#### Technical Note TN-902-SR

## TM8100 Mobile Radio Firmware v2.02 Upgrade Instructions

22 September 2004

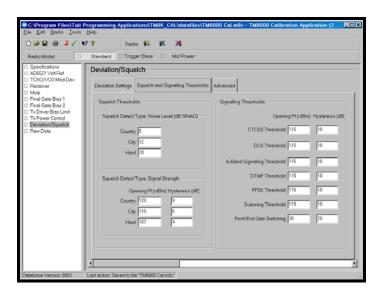
- The free format burst sequence preset boxes on the Free Format Bursts page can now display all 60 characters of a string as required.
